DART SERVICE INSTRUCTION

TO AMEND INSTALLATION INSTRUCTIONS D350-607-3 Rev.D,
INSTALLATION INSTRUCTIONS D350-607-4 Rev. C AND
INSTRUCTIONS FOR CONTINUED AIRWORTHINESS ICA-D350-607 REV. 6
REF TCCA STC: SH94-14
REF FAA STC: SR00213NY
REF EASA STC: EASA.10016996
REF BRAZILIAN STC: 2007S03-03/-04/-05/-06

A	NEW ISSUE	AJS	14.05.16
REV.	DESCRIPTION	BY	DATE
DESIGN	AJS	DART AEROSPACE LTD	
DRAWN	AJS	HAWKESBURY, ONTARIO, CANADA	
CHECKED		DRAWING NO.	REV. A
MFG. APPR.	N/A	DSI 9699	SHEET 1 OF 2
APPROVED		TITLE	SCALE
DE APPR.		LUG REPLACEMENT	NTS
DATE	14.05.16	COPYRIGHT © 2014 BY DART AEROSPACE LTD THIS DOCUMENT IS PRIVATE AND CONFIDENTIAL AND IS SUPPLIED ON THE EXPRESS CONDITION THAT IT IS NOT TO BE USED FOR ANY PURPOSE OR COPIED OR COMMUNICATED TO ANY OTHER PERSON WITHOUT WRITTEN PERMISSION FROM DART AEROSPACE LTD.

FIGURE 1: INSTALLATION OF D4775-041 FWD STRUT

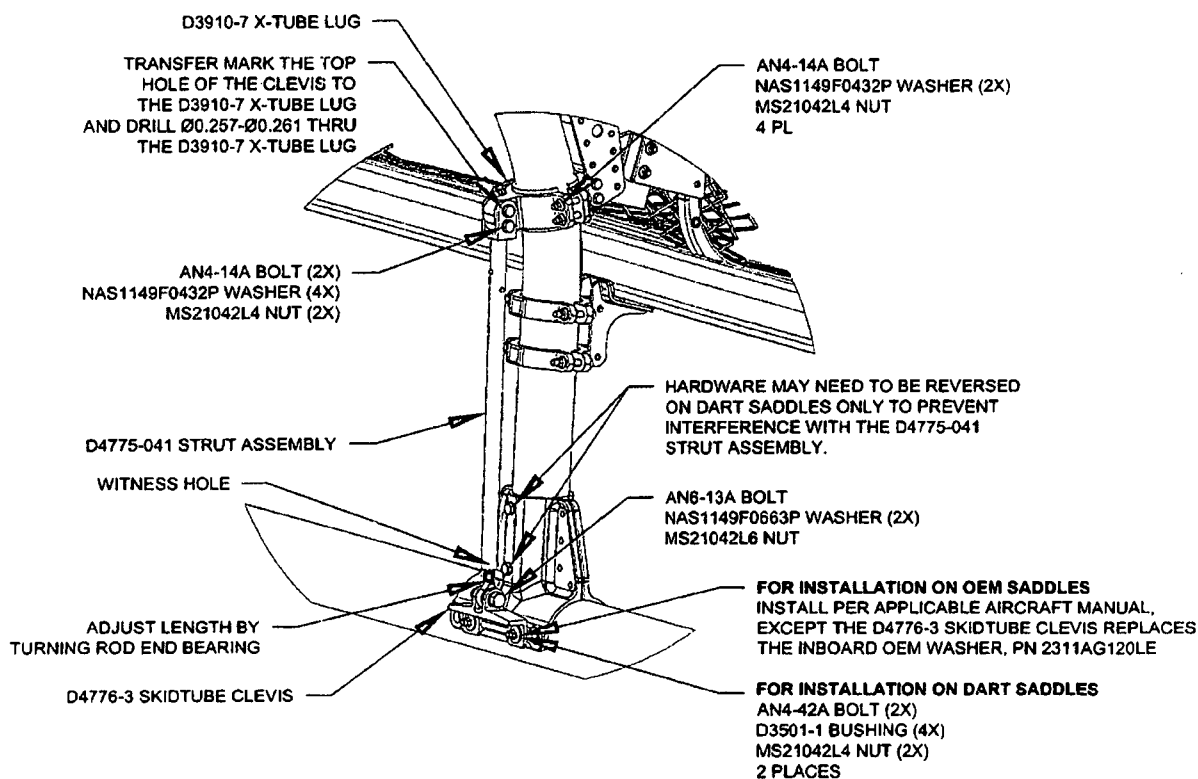
- 3.1 Substitute the Forward Lower D3910-5 X-Tube Lug with the D3910-7 X-Tube Lug as shown in Figure 1.
- 3.2 Install the forward D4775-041 Strut Assembly. Transfer mark from the upper hole on the clevis of the D4775-041 Strut Assembly to the D3910-7 X-tube Lug and drill thru the lug $\varnothing 0.257$ - $\varnothing 0.261$ as shown in Figure 1. Touch up chemical conversion coating per MIL-DTL-5541. Check the witness holes located at the bottom end of the D4775-041 Strut Assemblies to ensure that the thread from the rod end extends past the witness hole.
Torque MS21042L4/-4 nuts to 50-70 in-lbs (5.7-7.9 N-m). Torque MS21042L6/-6 nuts to 160-190 in-lbs (18.1-21.5 N-m).
- 3.3 Complete the installation in accordance with Installation Instructions D350-607-3 Rev. D or D350-607-4 Rev. C.
